Agenda Item # 20

SUB-003731-2026 & ZON-UDC-003732-2026

Sunset Estates Subdivision

- Subdivision approval to create three (3) legal lots of record.
- Rezoning from R-1 Suburban and B-2 Suburban to R-1 Suburban and B-3 Suburban.
- **Note:**
Any use permitted in the proposed district would be allowed at this location if the zoning is approved. The Planning Commission may consider other zoning districts than the proposed sought by the applicant for this property.

SITE PLAN

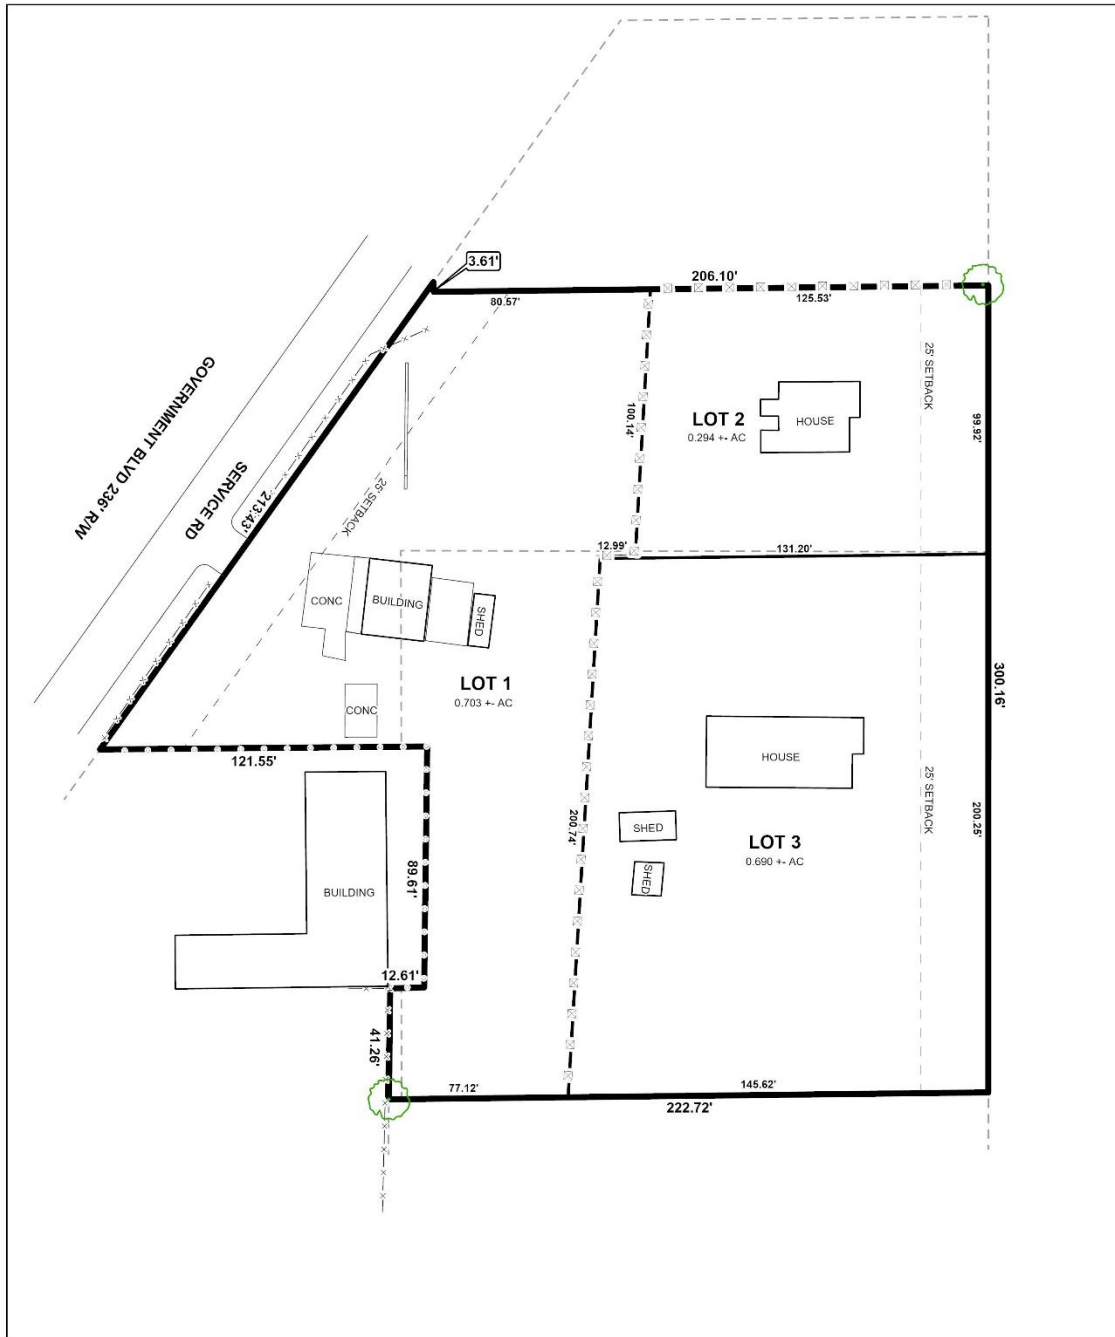
The site plan submitted with the rezoning application depicts the existing commercial structures and billboard on proposed Lot 1, as well as existing single-family dwellings and accessory structures on proposed Lots 2 and 3. No redevelopment plans were submitted as part of this request. Any future development or redevelopment of the properties will be subject to compliance with all applicable provisions of the Unified Development Code (UDC).

DETAIL SITE PLAN

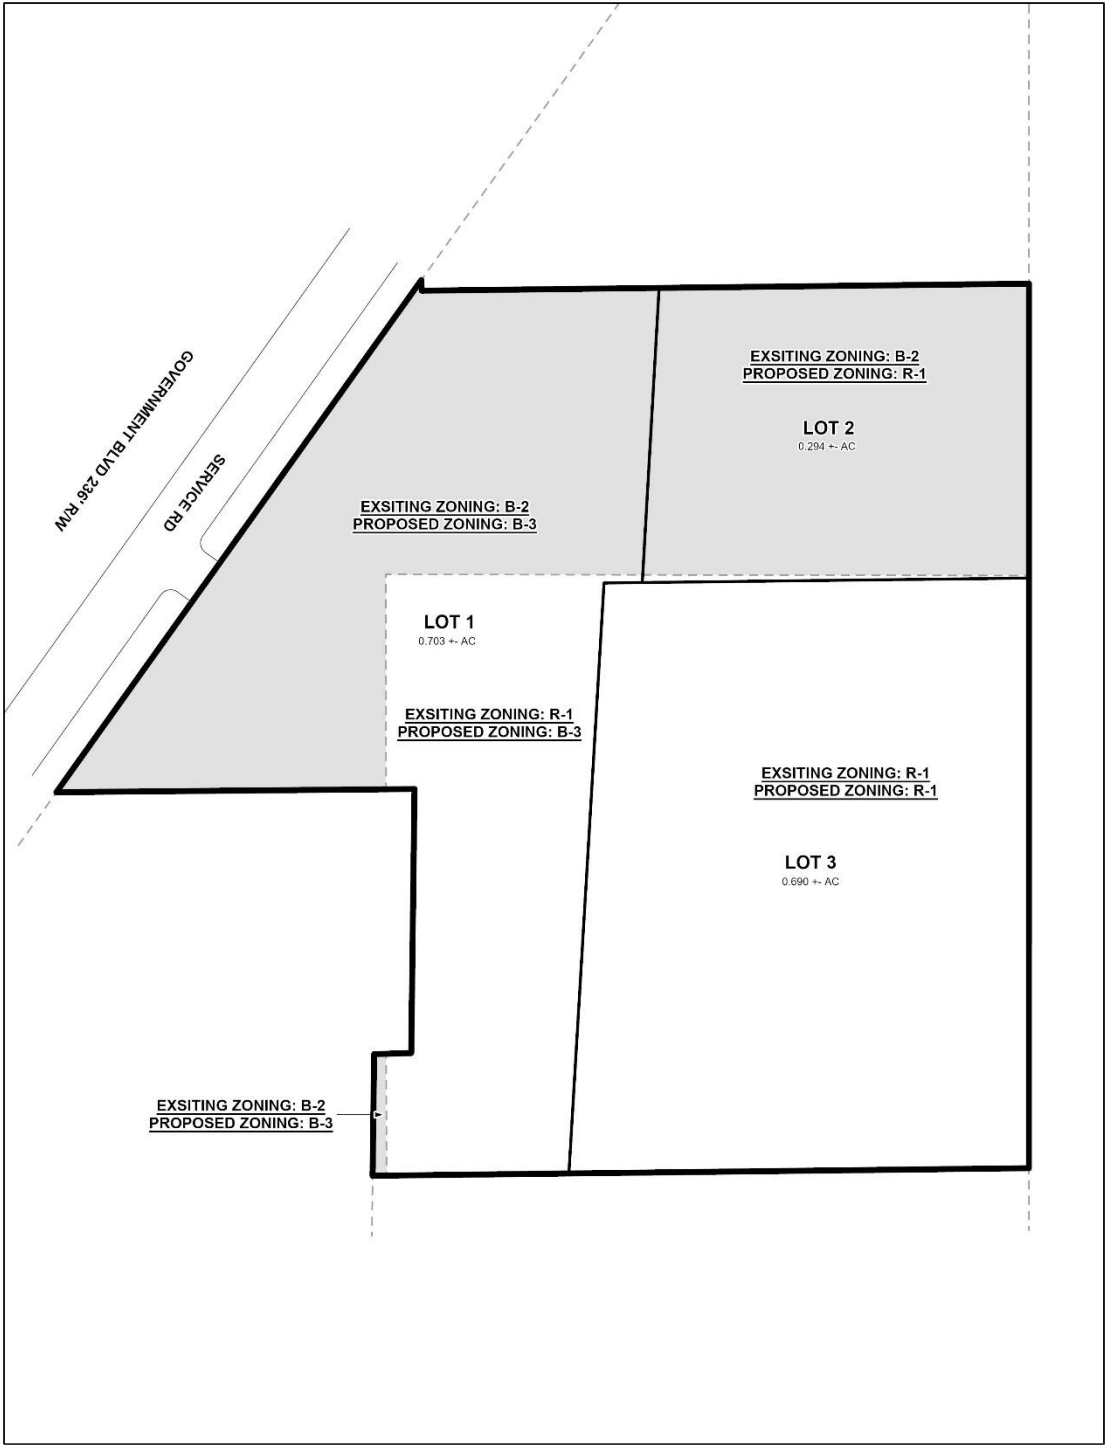
Proposed Lot 1 fronts Government Boulevard, an Alabama Department of Transportation-maintained Principal Arterial Street requiring a 250-foot-wide right-of-way at this location. Proposed Lots 2 and 3 front Mandrell Street, a minor street with curb and gutter improvements requiring a 50-foot-wide right-of-way.

The preliminary plat depicts Government Boulevard with a 236-foot-wide right-of-way. Therefore, if approved, the Final Plat should be revised to provide sufficient dedication to establish 125 feet from the centerline of Government Boulevard, unless a waiver of Section 6.B.9. of the Subdivision Regulations is approved upon recommendation of the City Engineer and Traffic Engineer. No additional right-of-way dedication is required along Mandrell Street.

All proposed lots exceed the minimum lot area requirements of Article 2, Sections 64-2-5.E. and 64-2-14.E. of the Unified Development Code (UDC) for properties served by public water and sanitary sewer. The preliminary plat properly identifies the area of each lot in both square feet and acres. If approved, this information should be retained on the Final Plat, adjusted as necessary to reflect any required right-of-way dedication. A lot area table may be provided in lieu of individual lot labels.

A 25-foot front yard setback is depicted along both Government Boulevard and Mandrell Street, consistent with Section 6.C.8. of the Subdivision Regulations and the applicable requirements of the UDC. If approved, the setback should be retained on the Final Plat and adjusted as necessary to account for any required right-of-way dedication.

1. Revision of the plat to illustrate dedication sufficient to provide 125 feet from the centerline of Government Boulevard, unless a waiver of Section 6.B.9. of the Subdivision Regulations is recommended by the City Engineer and Traffic Engineer;

2. Retention of the 50-foot-wide right-of-way along Mandrell Street on the Final Plat;
3. Retention of the lot sizes in both square feet and acres, or the provision of a table on the Final Plat with the same information, adjusted for any required dedication;

4. Retention of the 25-foot front yard setback line along all street frontages, adjusted for any required dedication, in compliance with Section 6.C.8. of the Subdivision Regulations;
